Salem Generating Station, Units 1 and 2  
Renewed Facility Operating License Nos. DPR-70 and DPR-75  
NRC Docket Nos. 50-272 and 50-311

Subject: Salem Generating Station Unit 1 Compliance with March 12, 2012 NRC Order to Modify Licenses with Regard to Reliable Spent Fuel Pool Instrumentation (Order Number EA-12-051) and Responses to Requests for Additional Information for Salem Units 1 and 2

**Salem Generating Station Units 1 and 2 Response to Interim Staff Evaluation and Request for Additional Information Regarding the Overall Integrated Plan for Implementation of Order EA-12-051 "Reliable Spent Fuel Pool Instrumentation"**

Figure 1 - Typical Mounting Sketch (Not to scale)  
Ref: PSEG Drawing 606366

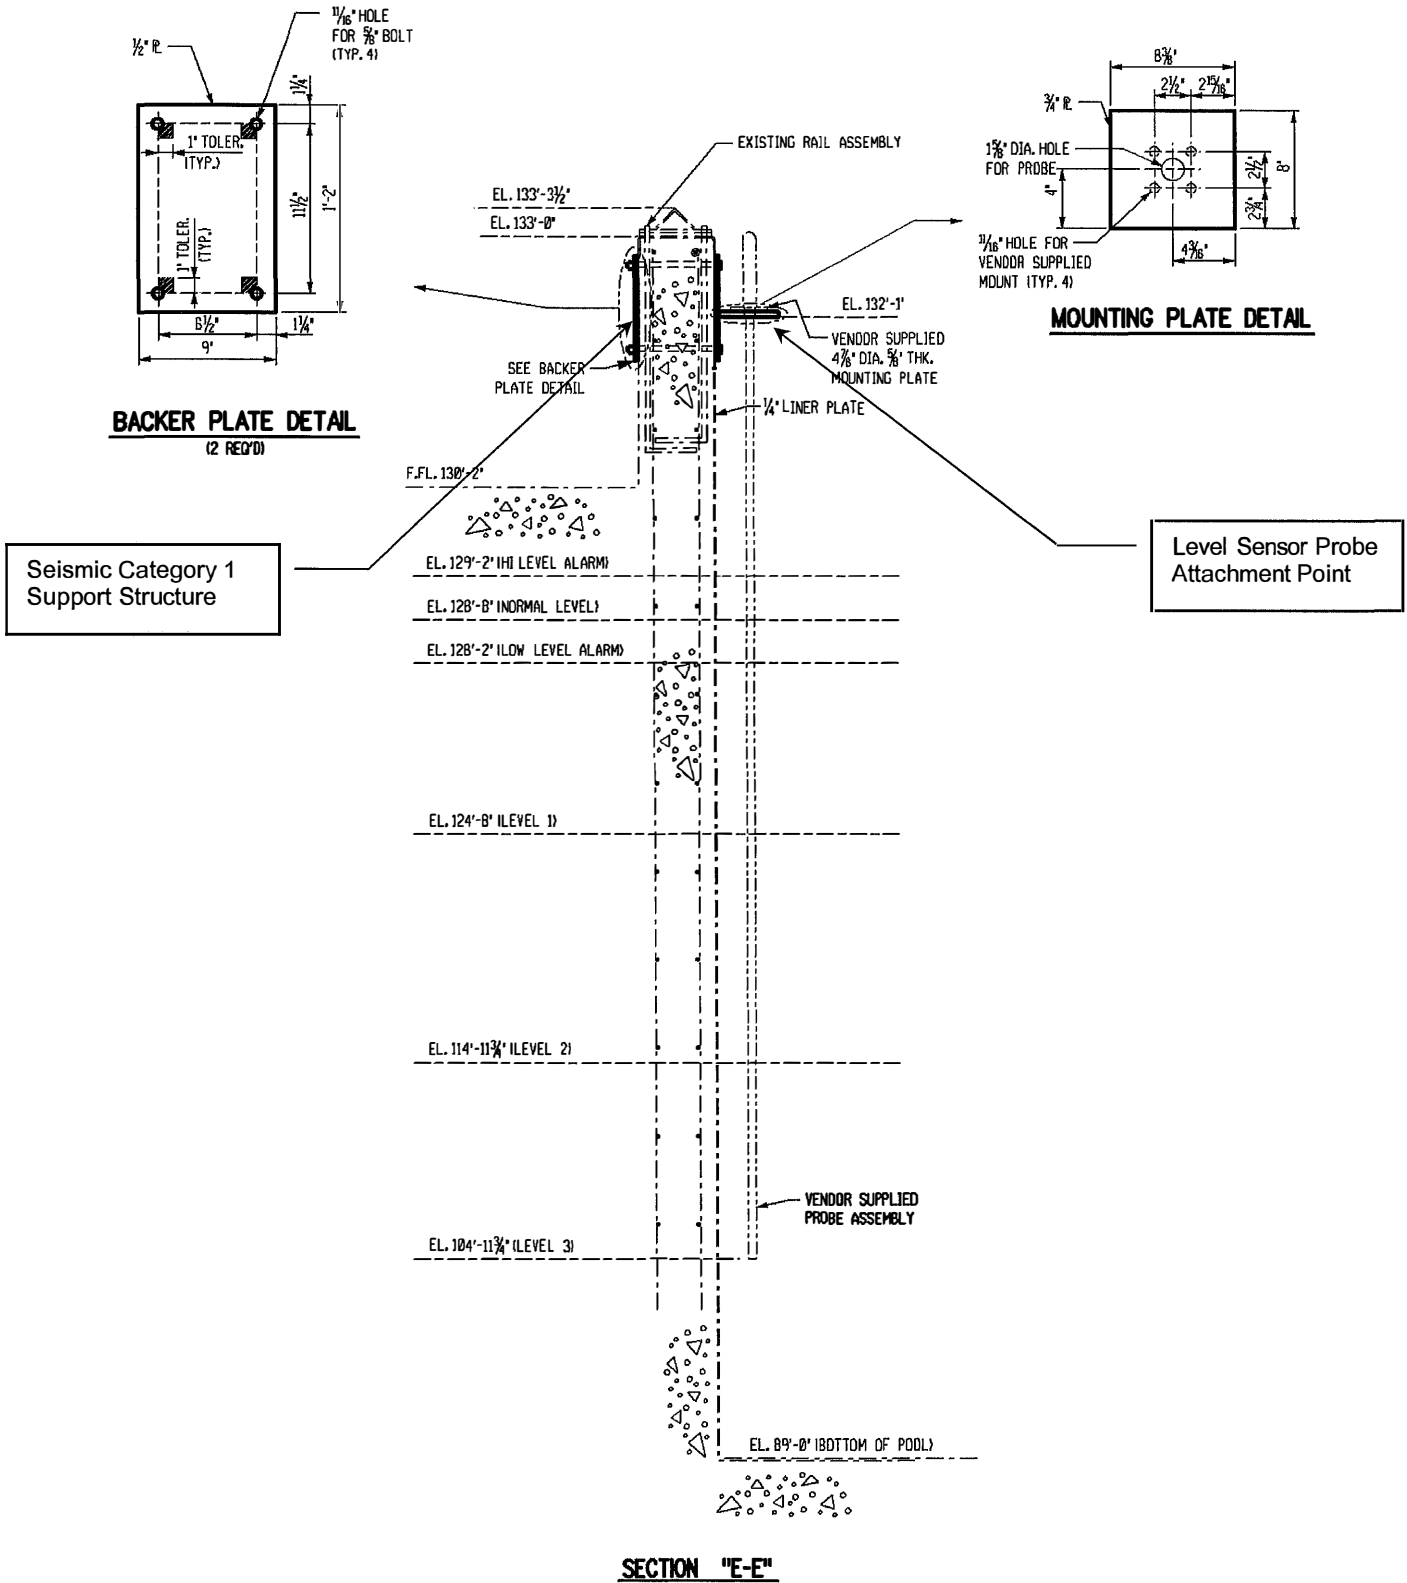
- b) A description of the manner in which the level sensor (and stilling well, if appropriate) will be attached to the refueling floor and/or other support structures for each planned point of attachment of the probe assembly. Indicate in a schematic the portions of the level sensor that will serve as points of attachment for mechanical/mounting or electrical connections.

- c) A description of the manner by which the mechanical connections will attach the level instrument to permanent SFP structures so as to support the level sensor assembly.

- c) The level sensor is designed to be attached near its upper end to the Seismic Category I support structure designed specifically to fit the SGS Unit 1 and 2 SFPs as shown in Figure 1.
